## Solicitation Addendum

**Addendum No.:** 3

**Solicitation Title:** Veterans Park Seawall Repair and Dock Replacement

**Addendum Date:** March 22, 2017

2 PROPOSED TYPICAL SEAWALL CAP  
S4.0  
1 0.5 0 1  
GRAPHIC SCALE IN FEET  
ADD ALTERNATE  
REPLACE REINFORCING WITH FRP, UON

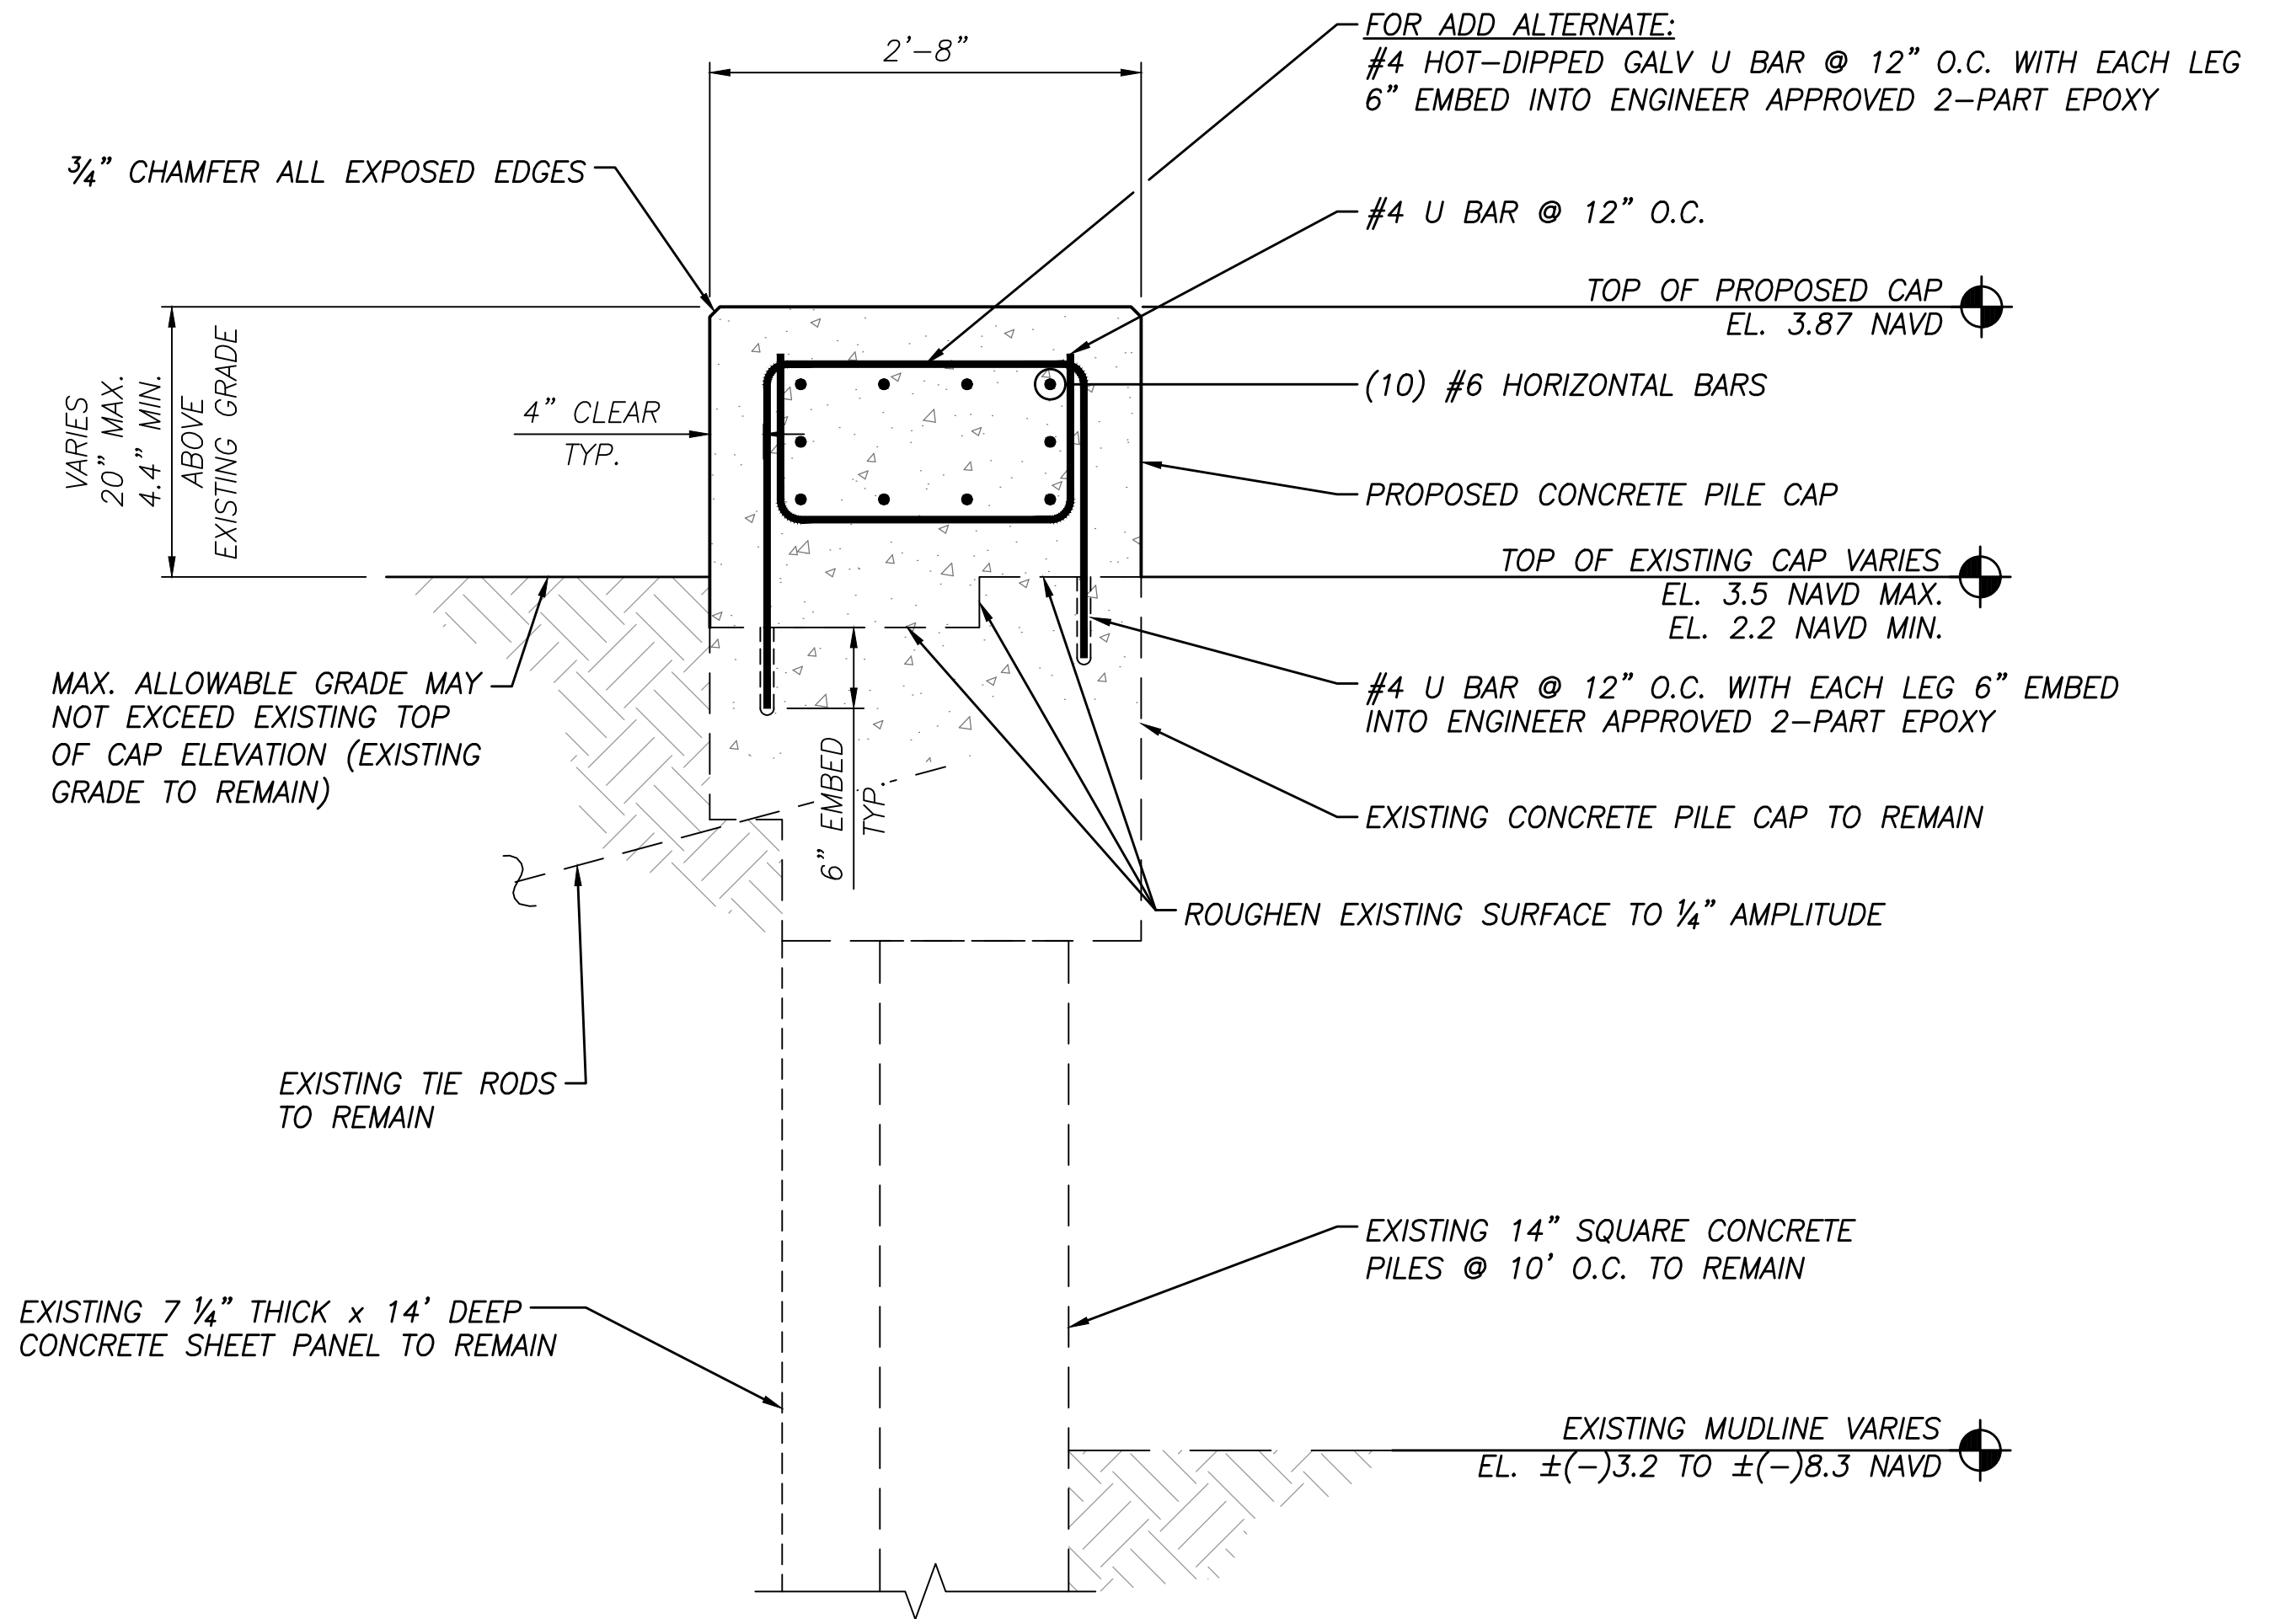
- Q2. Detail 2 on Sheet S4.0 specifies the finish elevation of the new cap as 3.897 NAVD. This detail also represents the maximum 20" raised cap. Detail 1 on Sheet S4.1 details an alternate cap to be used when the existing cap is within 8" of proposed cap. For the purposes of competitively bidding this project, and securing the best possible price for the City, is there a survey available that lists the current elevations of the existing cap so that we the bidders can determine how much of detail 2 on Sheet S4.0 (the large cap extension) or how much of detail 1 on Sheet S4.1 (the small cap extension) we are to bid on? Please advise.**

- R2. Sheet S2.0 is a survey of the existing wall with spot elevations along the length of the wall. Sheet S2.0 includes all survey information on the existing wall.**
